7<sup>th</sup> and 9<sup>th</sup> August 2018

Ref: 1444

### KOKO – Site Visit Report No.11

### 1.4 Number of props.

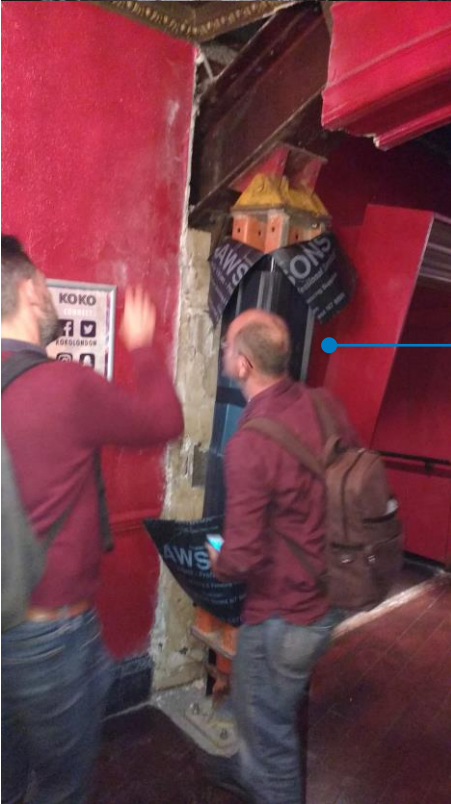
It was our understanding that double mega-shores would be required (at least in the outermost locations) to carry the loads from the existing truss. Has the single prop solution been justified and signed off by the temporary works engineer?

If not, we strongly recommend that this is remedied as soon as possible as we do not believe that the truss can safely carry the load imposed on it.

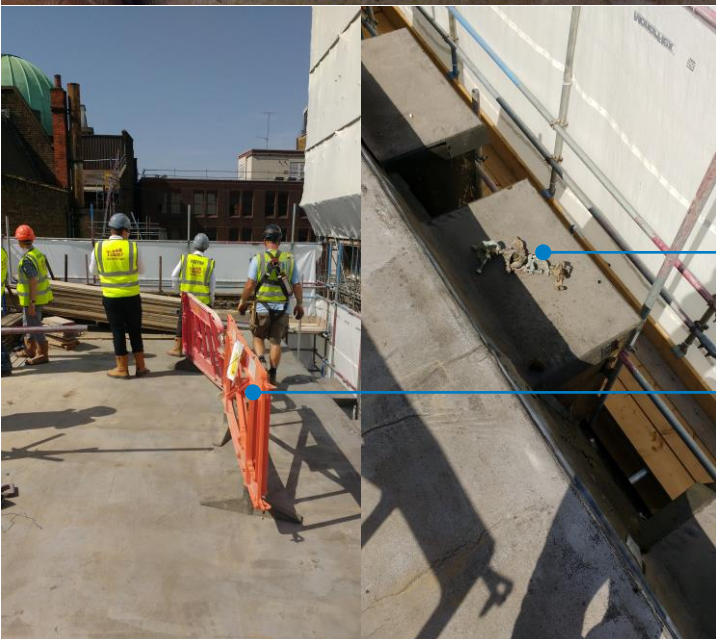
2.2 There are piles of old stone and brick loading the existing structure. Tower Demo noted that this has been allowed in their design, but we have not seen any calculations justifying this.
